13–007 Air Compressor Discharge Line Blocked by Ice in Cold Weather

TSB-13-007-FTL

- ▶ eM2
 - ▶ eCascadia
-

Fig. 1, Removing Bolts of the Overflow Valve

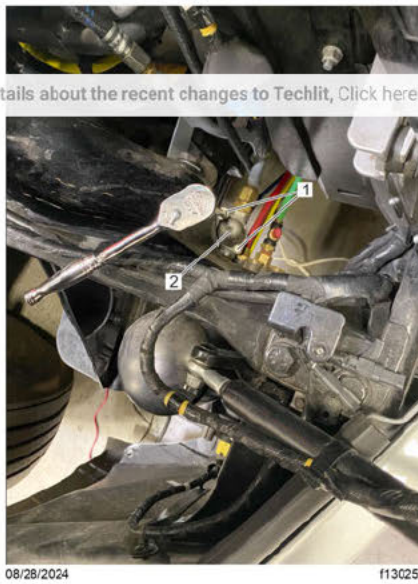
3. Remove the two bolts from the top of the overflow valve. See Fig. 1.

4. Replace the overflow valve.

5. Install the bolts. Tighten the bolts 62–80 lbf-in (700-904 N-cm).

Fig. 4, Insulated Discharge Line

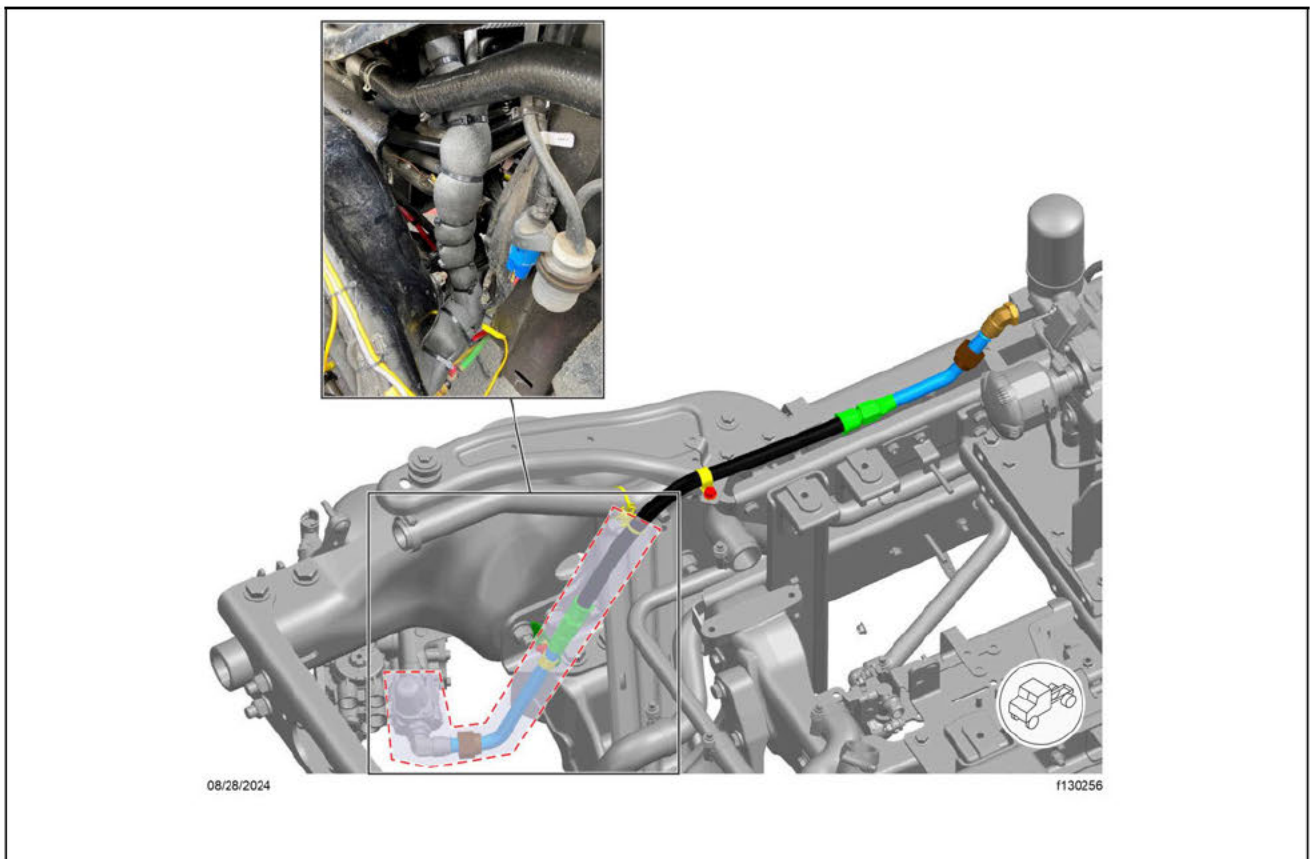
14. Apply insulation (part number 48–02159–124) over the lower metal section of the discharge line and over the overflow valve.

15. Install the tie straps. See Fig. 4.
